SI M12 02 18
Engine Electrical Systems

SERVICE ACTION: ENGINE HARNESS RE-ROUTING

F56 (MINI Cooper S)

Repair Procedure: Secure Engine Harness to B+ line (def code 0012660300)

Remedy

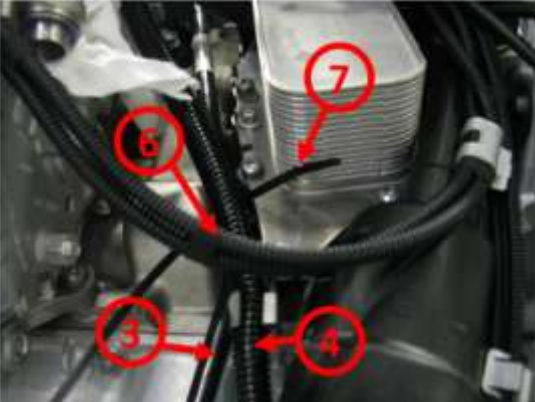
Part of the engine wiring harness, specifically connection to the A/C compressor and to the thermostat, may contact blades of the electric fan.

In such a case, electric cables may be damaged causing Check Control messages to be displayed and certain faults stored in the DME and IHKA control modules.

Incorrect routing of the engine harness.

Re-route and secure engine harness to the B+ line, following the attached procedure.

Secure engine harness to B+ line

2.		<p>Remove under car cover.</p> <p>Red circle → area of repair</p>
3.		<p>Faulty wiring harness. Cable for A/C compressor and MAP thermostat reach into radiator fan area.</p> <ol style="list-style-type: none">1. Harness for Map thermostat and A/C compressor.2. Fan shroud3. Oil filter4. B+ cable for starter5. Tank vent line (TEV)
4.		<p>The cable tie should be installed as seen in the graphic.</p> <p>The harness for the MAP thermostat and A/C compressor is to be placed in front of the B+ line (4) and the tank vent line (3).</p> <p>The cable tie (7) should be placed behind the B+ line (4) and the tank vent line (3).</p> <p>The cable tie should be placed at the height of the oil cooler.</p>

5.		<p>When tightening the cable tie pull the harness (6) in direction of the arrow (A/C compressor) and make sure that there is enough space between the harness and the oil cooler.</p>
6.		<p>When closing the cable tie make sure that the harness does not reach into the radiator area. Cut the wire tie end off.</p>
